Ref:	NR/L2/ELP/27009/MOD C76
Issue:	1
Date:	03/12/2011
Compliance date:	03/03/2012
Page	1 of 2

OVERHEAD LINE CAMPAIGN CHANGES – DATA SHEET	
76	LEVER ARM MODIFICATION TO ARTHUR FLURY NEUTRAL SECTIONS
COMPONENT	Arthur Flury skidless neutral sections, where there is no lever arm fitted on the entry end of the neutral sections.
PROBLEM	<p>The original design of this neutral section tended to flex at the entry end, at the splice between the contact wire and the insulator ferrule. This caused poor wear at the interface, leading to pantograph damage. This was particularly a problem in high speed lines.</p> <p>This campaign change relates to special inspection notice NR/SIN/111. That notice should be read as well as this campaign change.</p>
 <p>Arthur Flury skidless neutral section without lever arm.</p>	
Reference Information	
Ellipse standard job number	008041
Ellipse standard job description	
Category	Neutral sections
Priority	Yes (where line speed is 100 mph or greater)
Types of OLE affected	All

LEVER ARM MODIFICATION TO ARTHUR FLURY NEUTRAL SECTIONS

Lever arm and arcing horn retrofit kit

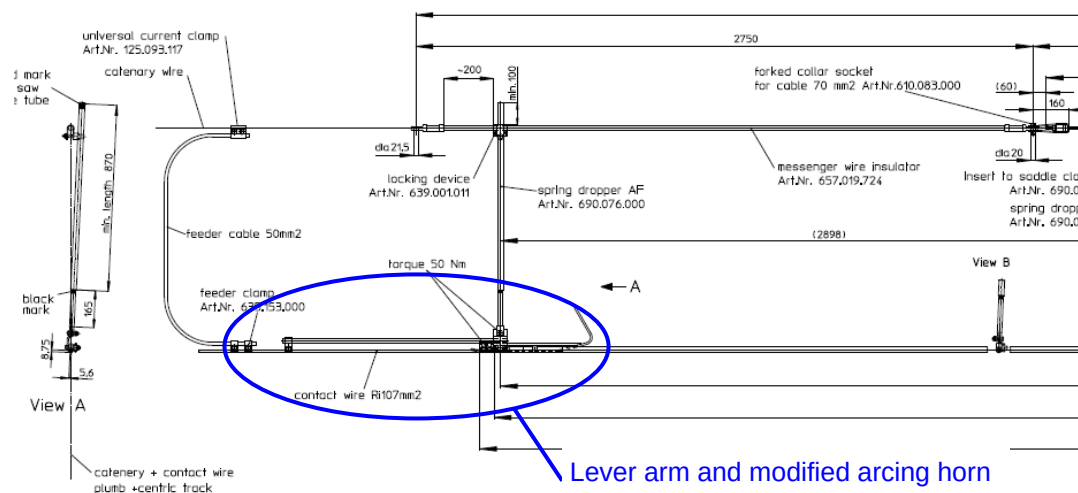
Fit the lever arm and arcing horn modification kit as follows. This lever improves the profile and stiffness of the neutral section at the joint between the contact wire and the neutral section ferrule.

Item	Part number	PADS number
Lever arm assembly for neutral section (retrofit kit)	659.500.373	091/013237

Modified neutral section (with old arcing horn shown)

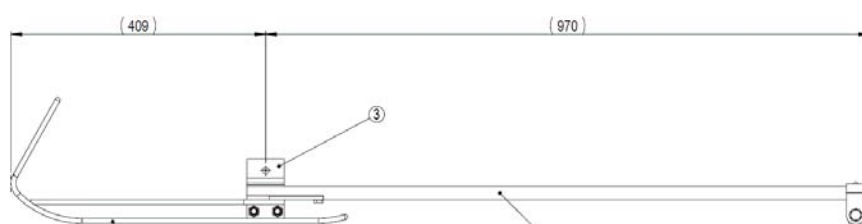
Note that all assemblies delivered from December 2010 on have the new design with the lever arm and modified horns.
